REQUEST FOR INFORMATION	DATE: July 08, 2016	NO.: RFI-195
--------------------------------	----------------------------	---------------------

Project Name: 15051-Webster University Interdisciplinary Science Building	Project No.: 15051
---	--------------------

Subject: Added gusset plates

4 FRAMING SECTION
3/4" = 1'-0"

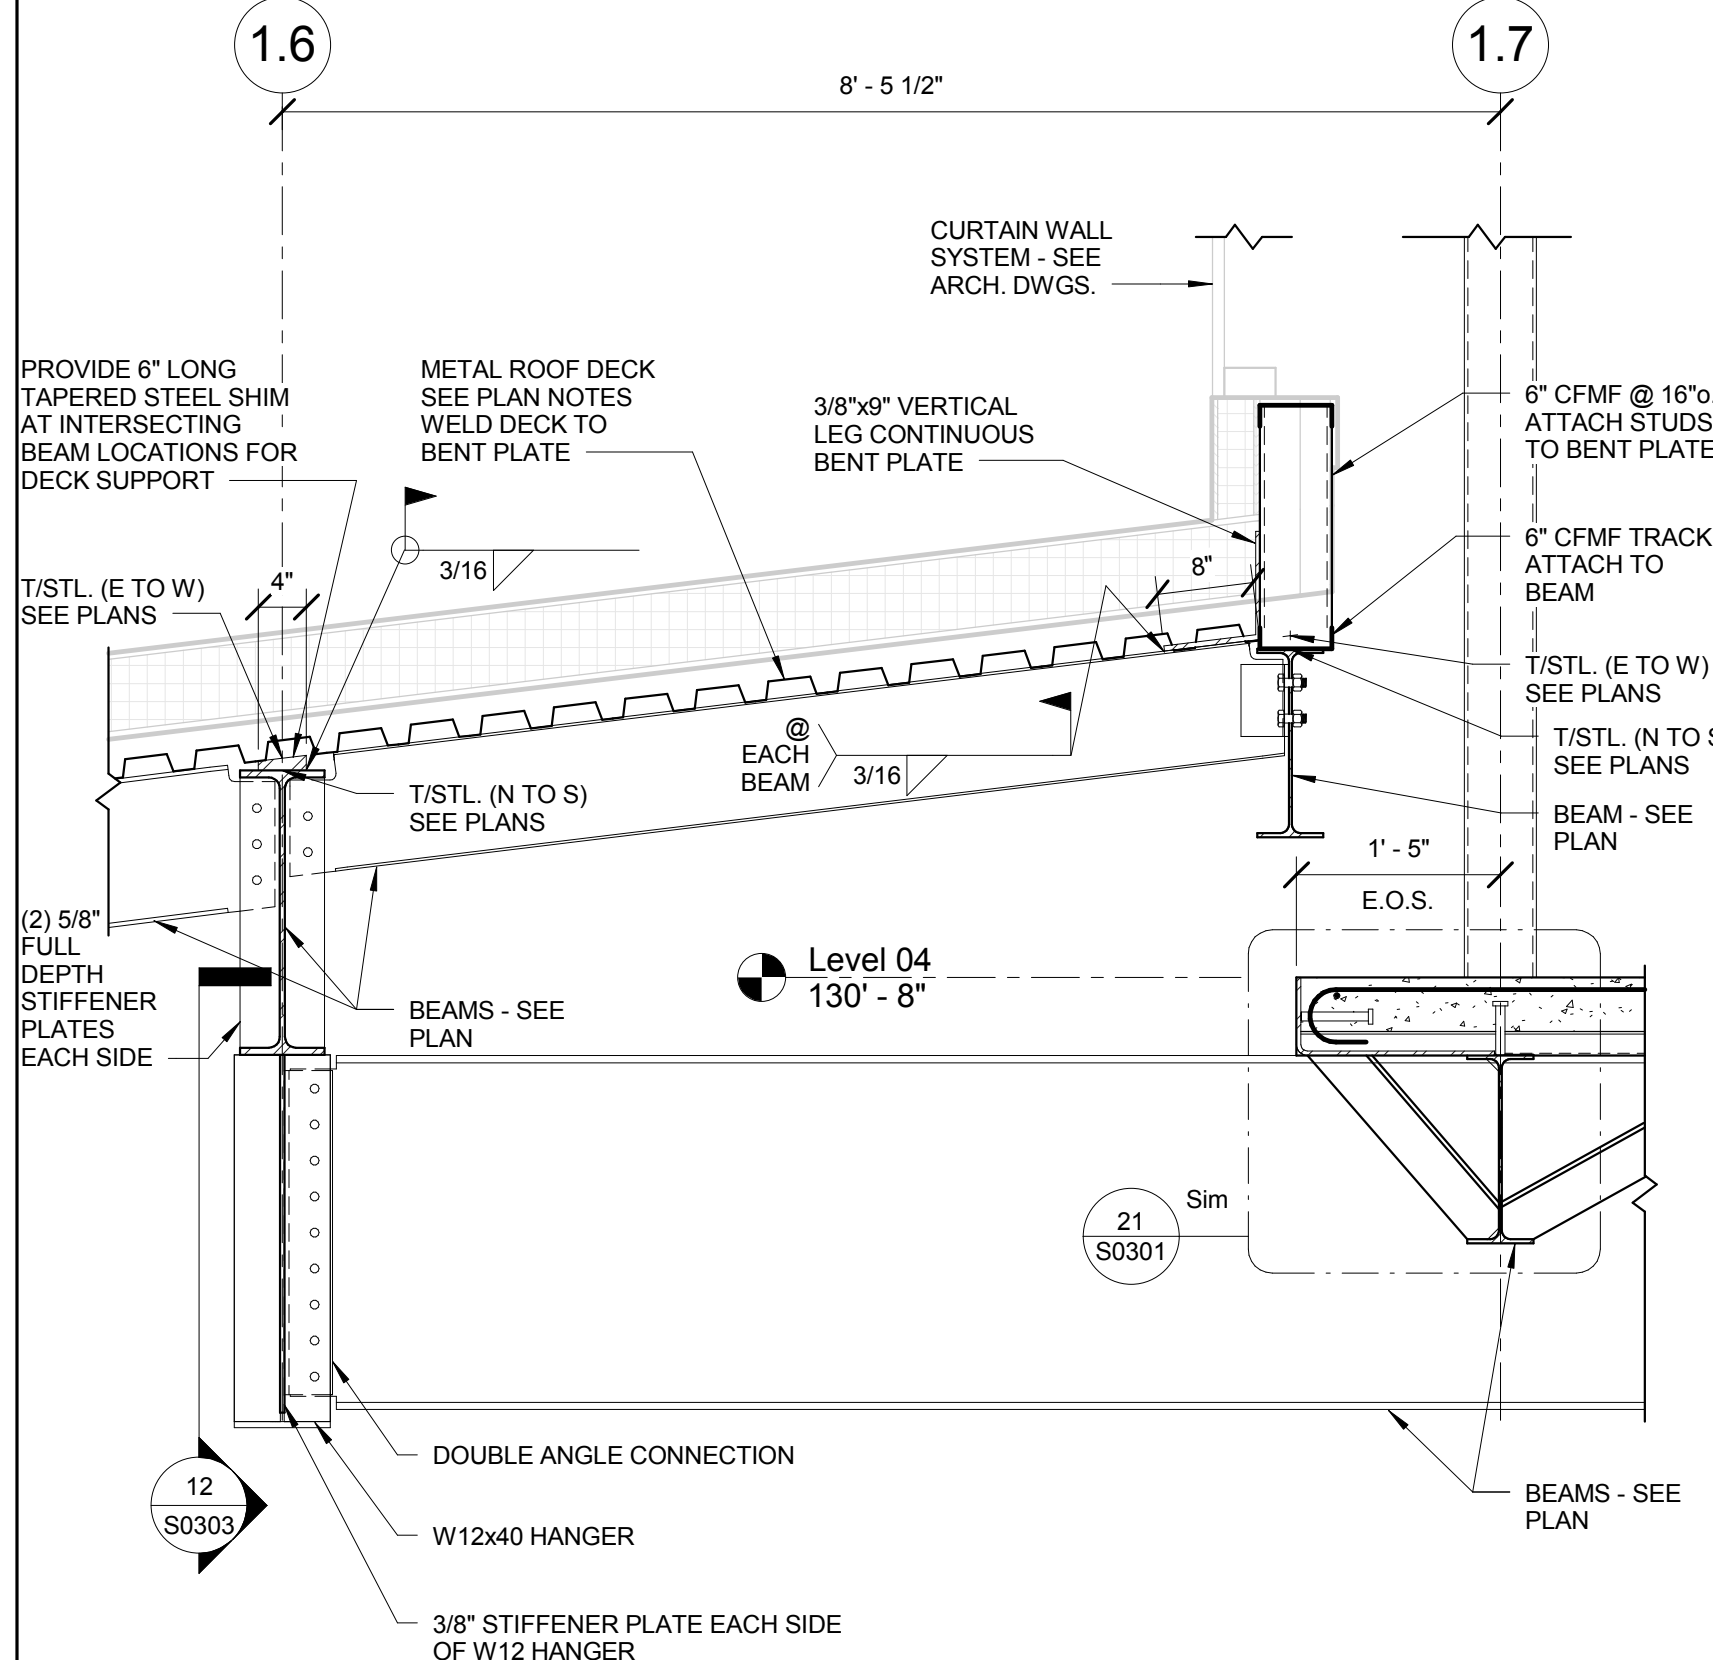
RFI 135 stated that "at roofs, detail 7/S0302 is missing the linework for the exterior gussets (as are 4/S0302, 4&15&22/S0303, and 13/S0304). Typical roof edge details are to follow 5&6/S0303."

Please provide revised contract documents showing these changes so that the documents may be interpreted correctly.

Attached revisions - formal document submission at future date.
4 & 7 / S0302 and 4 & 22 / S0303 included
15/S0303 is located at high roof and is unchanged.
13/S0304 refers to 7/S0302 and therefore is not included.
17/S0303 stiffener spacing reduced from 24"o.c to 48"o.c.
